3480
SL-029093
(U-066)

Moab District
Price River Resource Area
500 North 700 East
Price, Utah 84501

Your proposal for minor modification of the No. 3 Mine approved mine plan, received by this office March 11, 1988, has been reviewed.

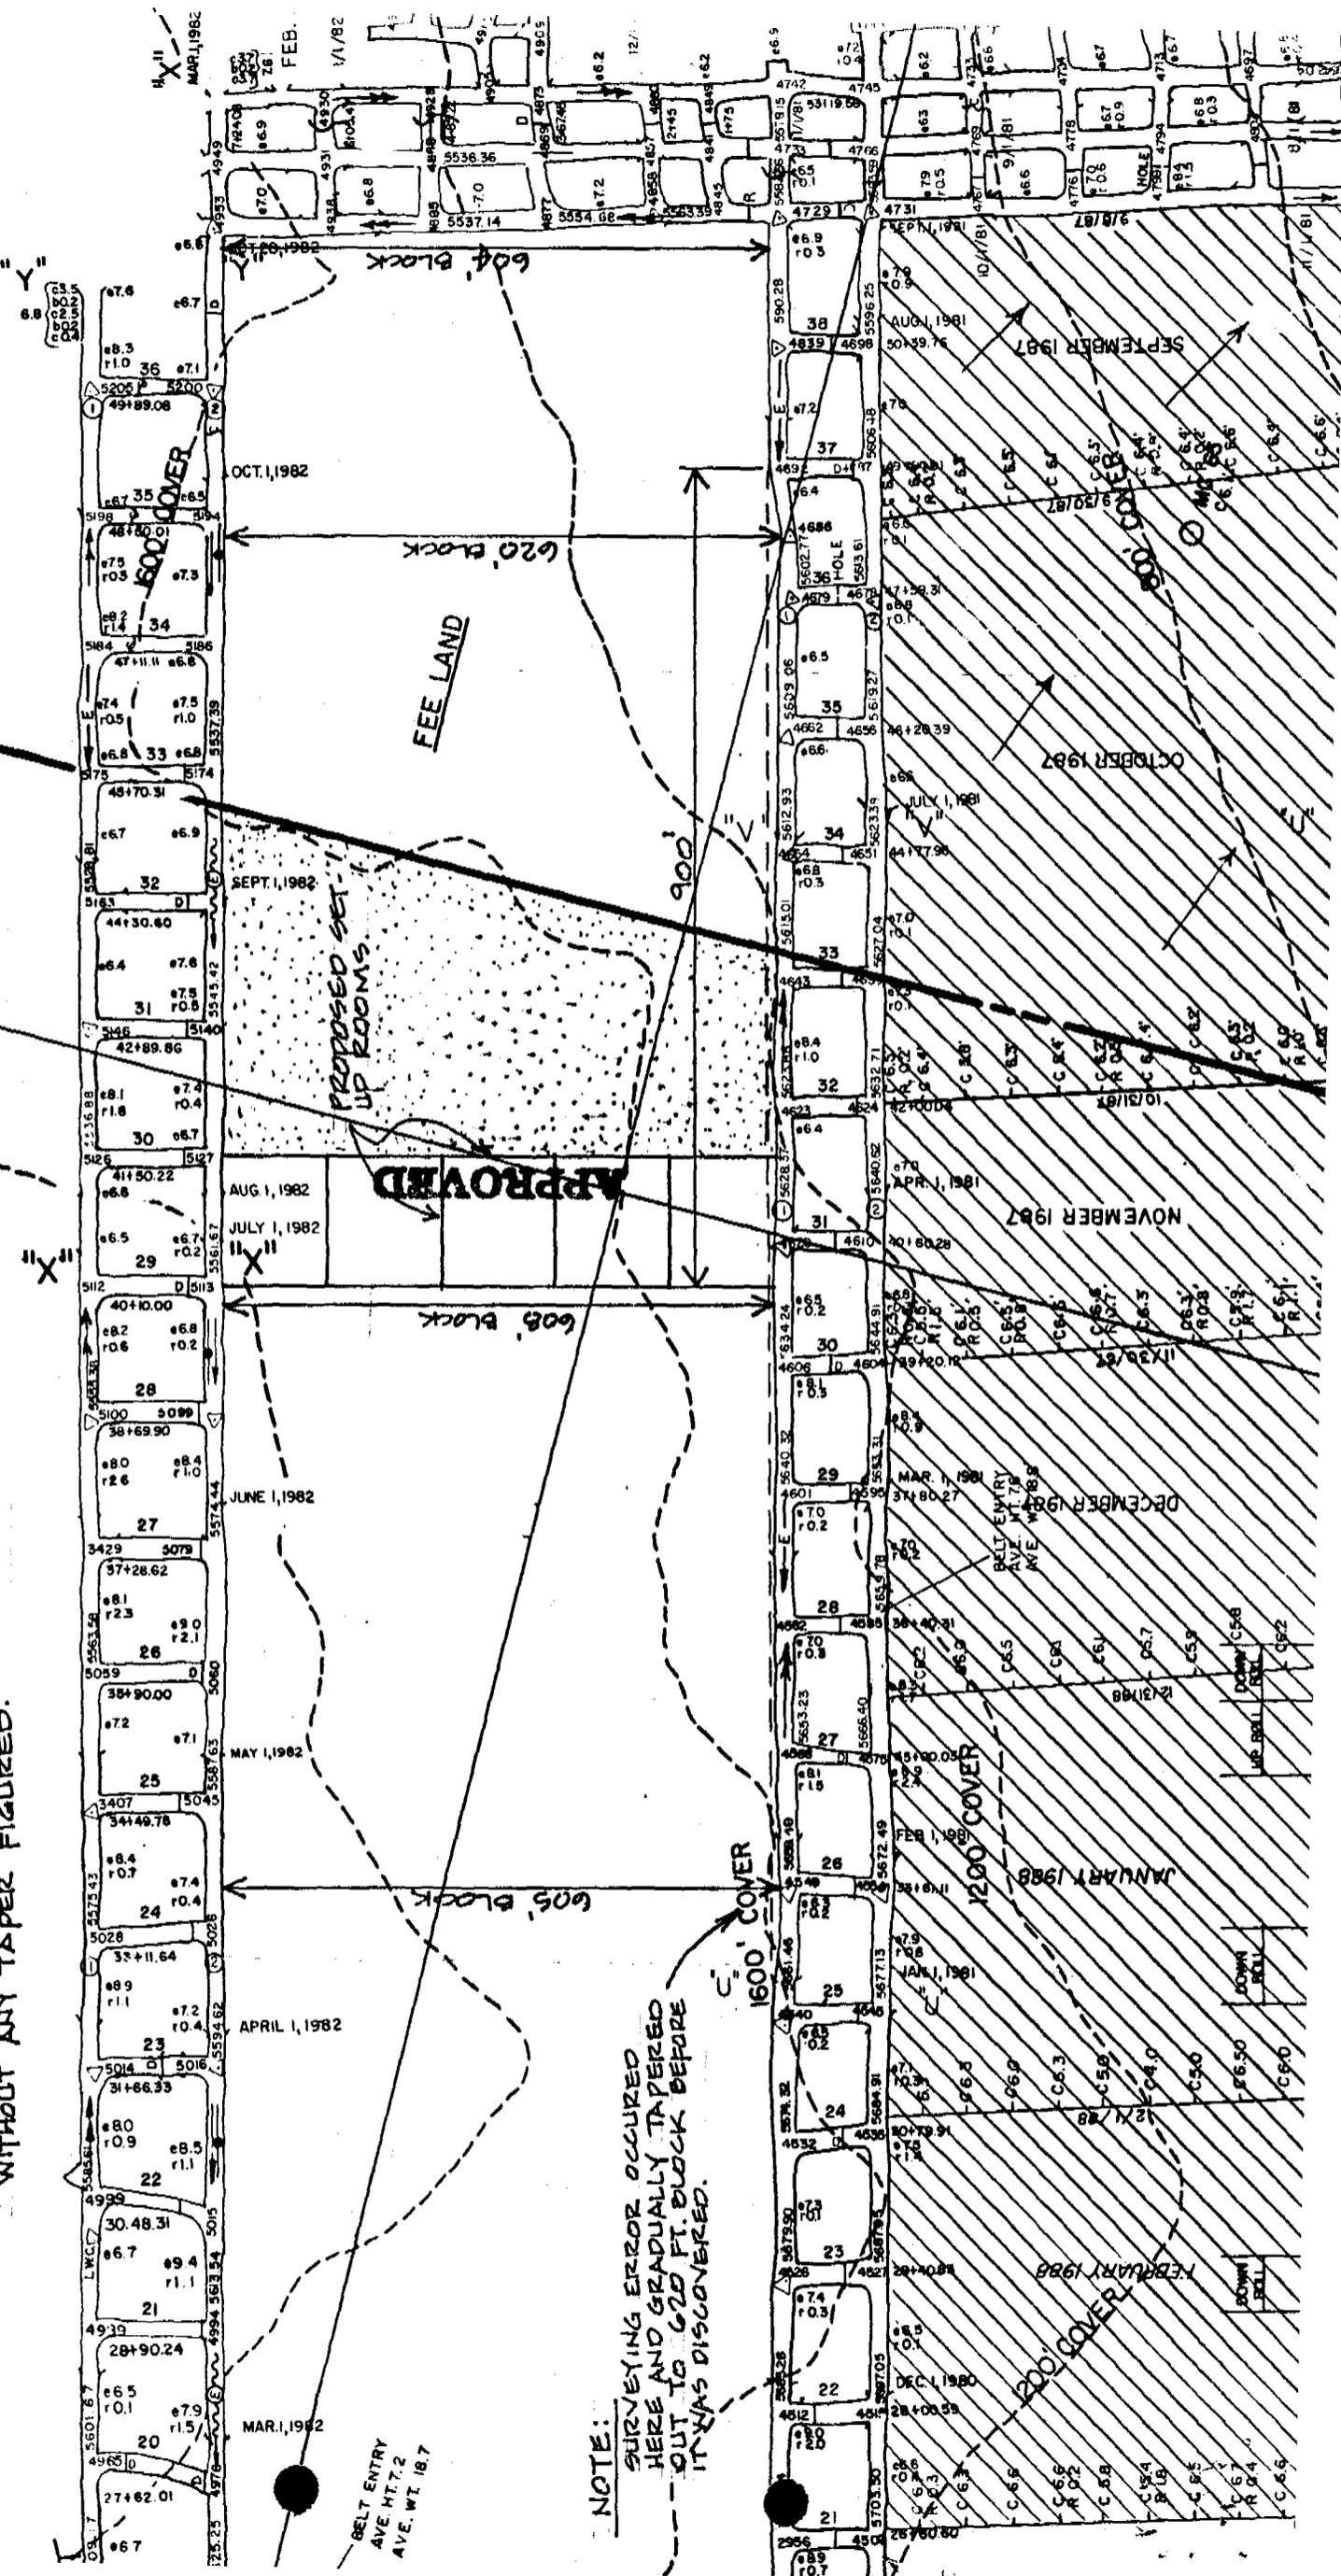
The abandonment of approximately 1,150 feet of the 8th East panel has been deemed necessary because of a survey error by the previous operator which occurred when the 8th East two-entry section was driven, as shown on your enclosed map. Various methods of mining through this area have been explored and several are technically possible, however, none of them are feasible from either an economic or safety point of view. This office calculates that 62,500 tons of raw coal, or 49,600 tons of clean Federal coal will be abandoned because of this action.

Through discussions with your office, we have learned that a third set-up entry will probably be driven at crosscut 31 for ventilation purposes. We encourage you to drive this entry and to recover as much of this abandoned coal as possible.

As undesirable as this situation is, we realize that it was created through no fault of Castle Gate Coal Company, and therefore this minor modification is approved as proposed.
